| 4. TITLE AND SUBTITLE DRAFT FINAL DECISION DOCUMENT FOR THE BASIN A NECK GROUNDWATER INTERCEPT AND TREATMENT SYSTEM, INTERIM RESPONSE ACTION AT THE ROCKY MOUNTAIN ARSENAL | | 5. FUNDING NUMBERS | |

DRAFT FINAL DECISION DOCUMENT
FOR THE BASIN A NECK GROUNDWATER INTERCEPT
AND TREATMENT SYSTEM INTERIM RESPONSE
ACTION AT THE ROCKY MOUNTAIN ARSENAL

COMMENTS ON THE PROPOSED DECISION DOCUMENT
FOR THE INTERIM RESPONSE ACTION FOR
BASIN A NECK GROUNDWATER INTERCEPT AND TREATMENT SYSTEM
SEPTEMBER, 1988

RESPONSES TO COMMENTS BY THE U.S. ENVIRONMENTAL
PROTECTION AGENCY, REGION VIII, ON THE PROPOSED DECISION
DOCUMENT FOR THE INTERIM RESPONSE ACTION FOR THE
BASIN A NECK GROUNDWATER INTERCEPT AND TREATMENT SYSTEM
SEPTEMBER, 1988

Figure 5.

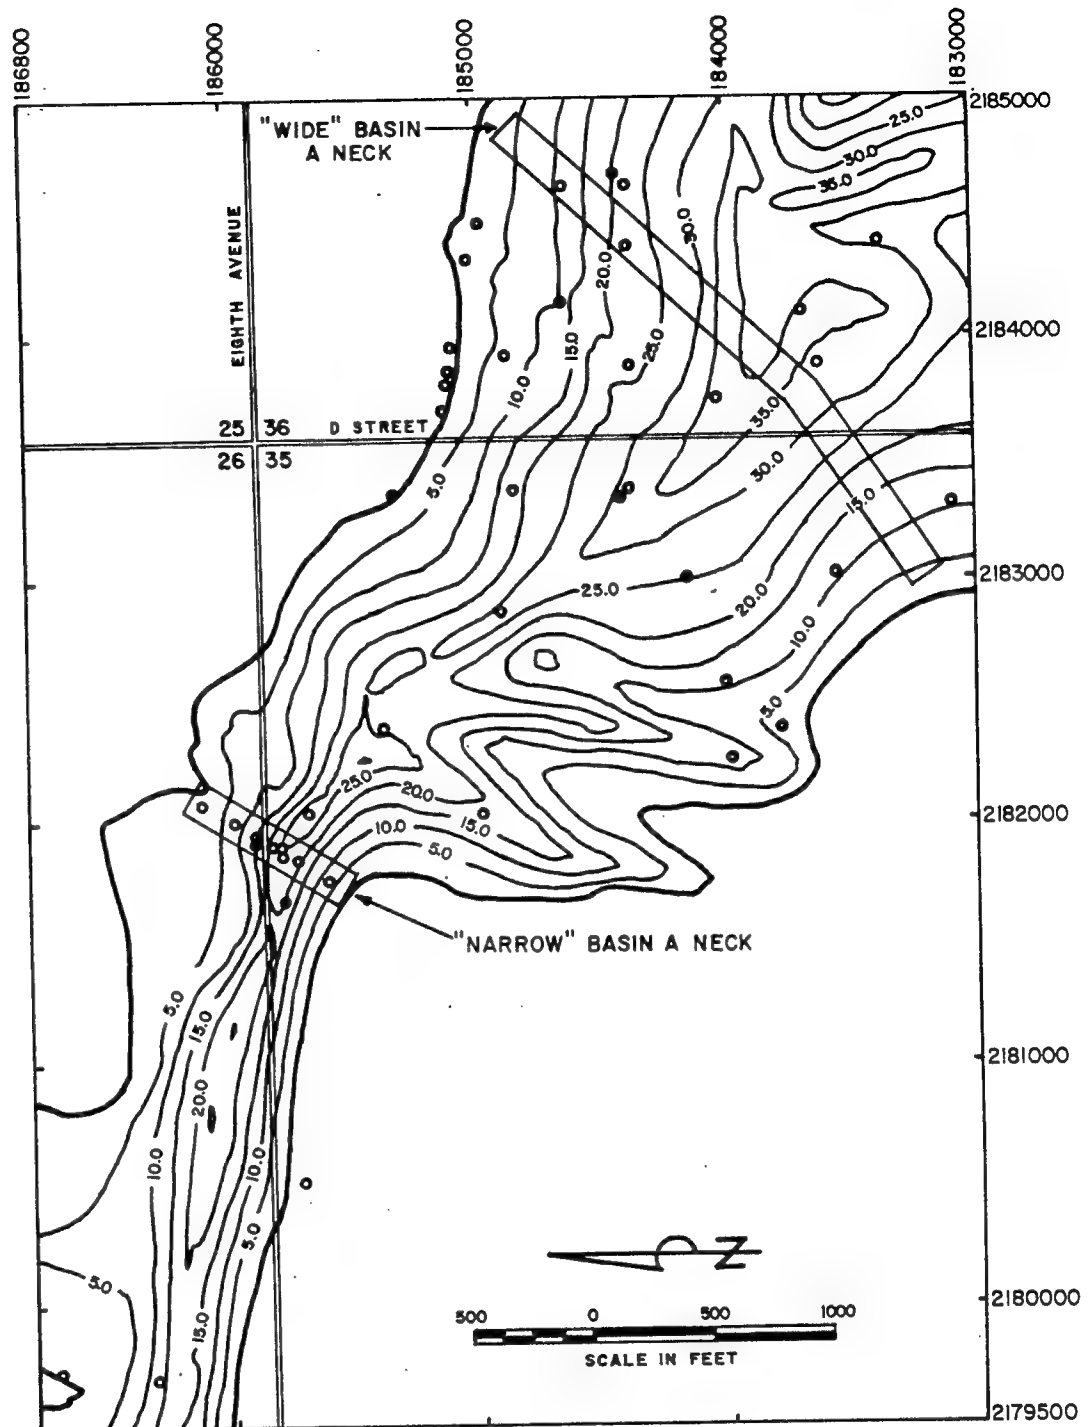
elevations in Figure 4 from the water table elevations in Figure 3, Figure 5 was produced showing the estimated saturated alluvial thicknesses in the Basin A Neck Area. As shown in Figure 5, the thickness of the saturated alluvium in the Neck area varies from 0 to more than 35 feet, and the width varies from about 800 feet in the narrowest section to about 2,800 feet in the wide section.

Response: As shown on Figure 5, the width of the saturated alluvium in the area of the "wide" Basin A Neck is approximately 2800 feet. Such a statement has been incorporated in the text.
